ADDENDUM NO. 2

Whiteland Community High School Phase 2A
300 E. Main Street
Whiteland, IN 46184

PROJECT: Whiteland Community High School Phase 2a

DATE OF ADDENDUM: May 2, 2024

ES202

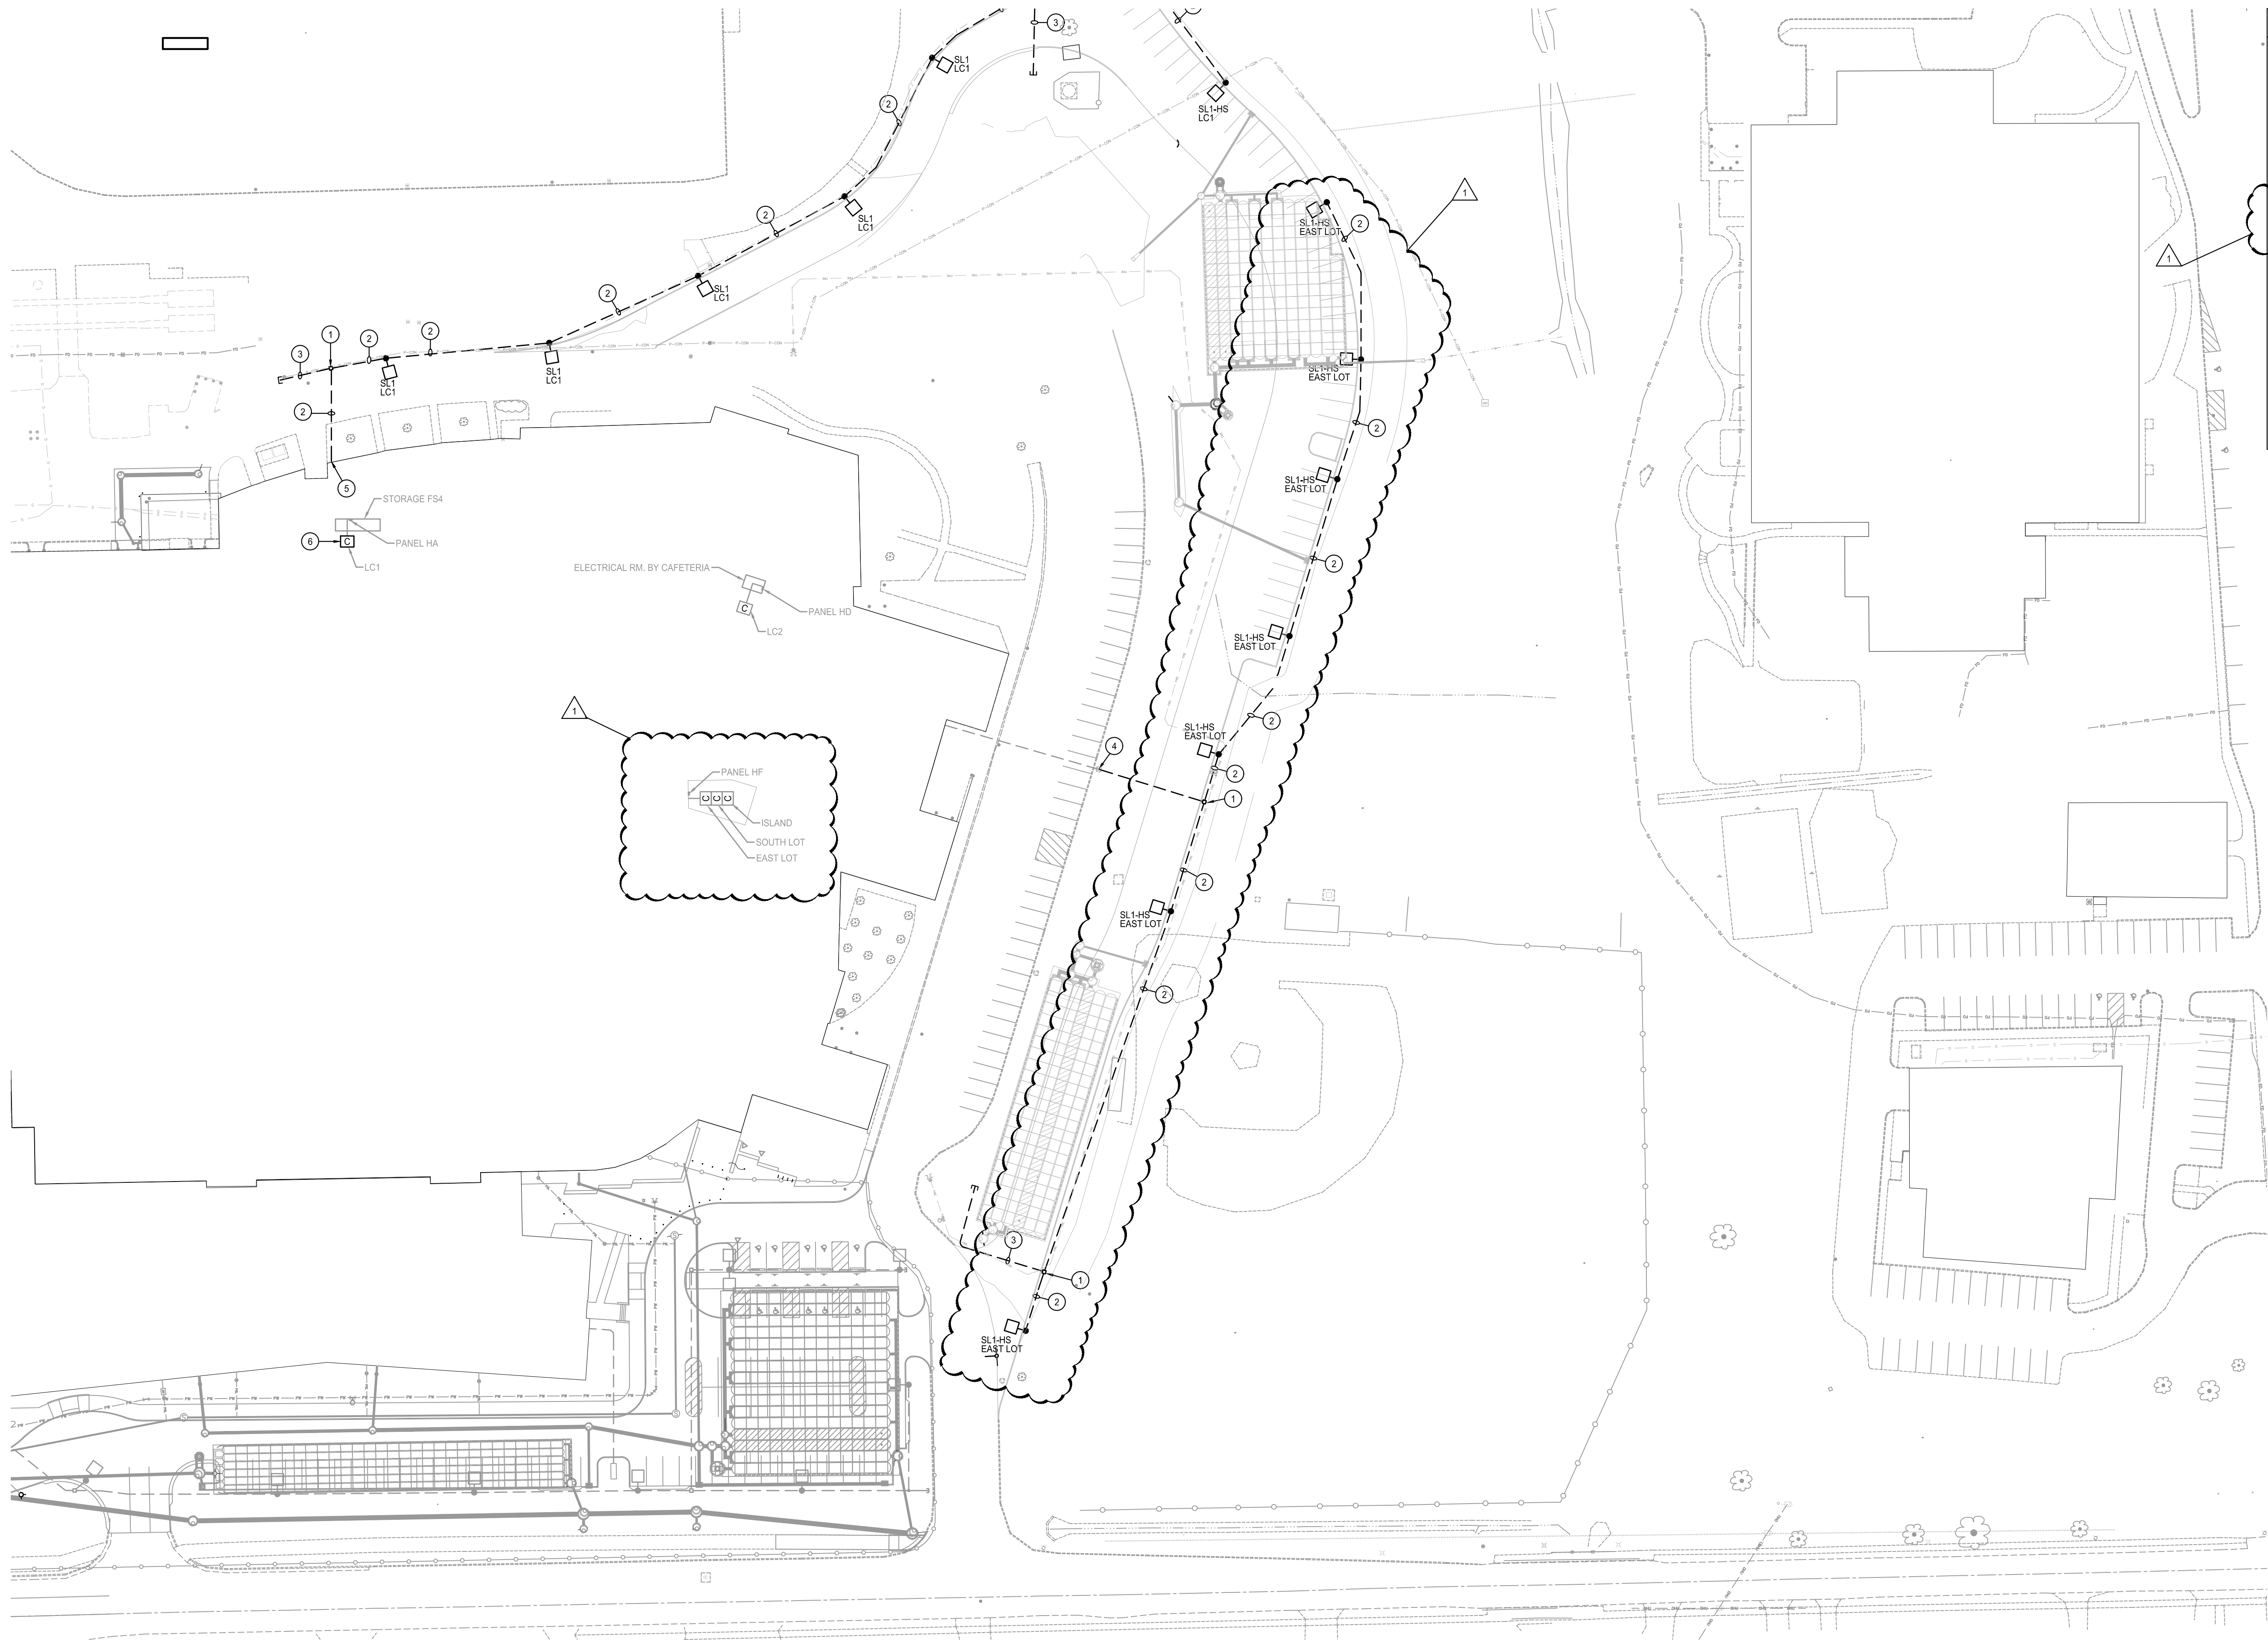
25. Drawing Sheet ES202

Drawing Sheet Title: Electrical Site Demolition Plan

- a) Drawing #1: Relocation of football field transformer.
- b) Plan notes: Added additional plan notes.
